WOODMOOR WATER & SANITATION DISTRICT NO. 1

WOODMOOR WELL NO. 22

TRANSMISSION LINE

SWMP, GRADING AND EROSION CONTROL PLAN

WELL NO. 22 TRANSMISSION LINE PLAN

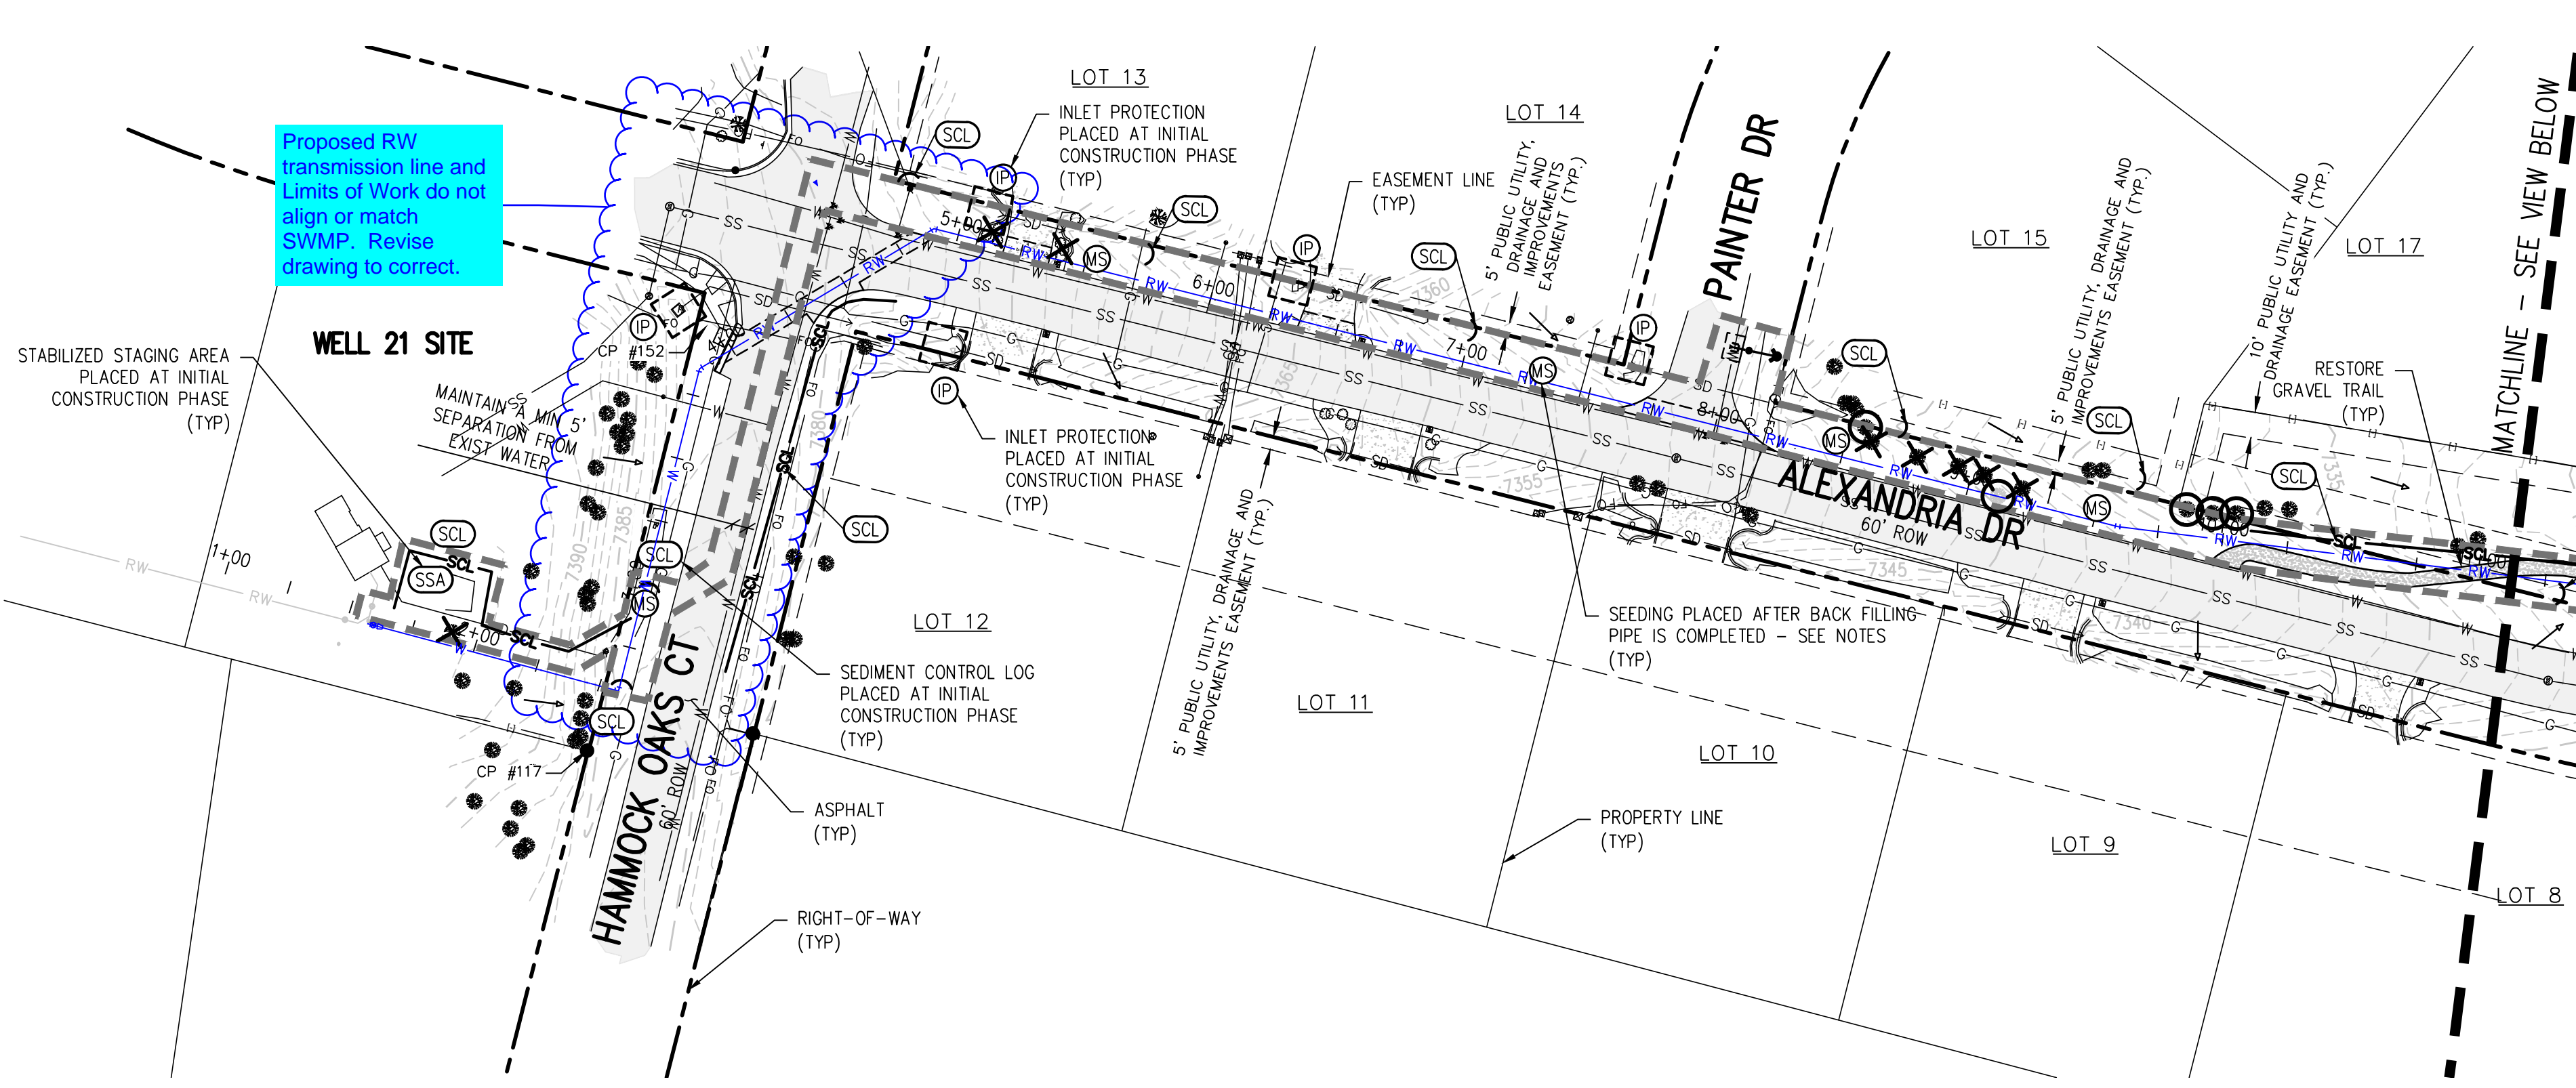
Proposed RW transmission line and Limits of Work do not align or match SWMP. Revise drawing to correct.
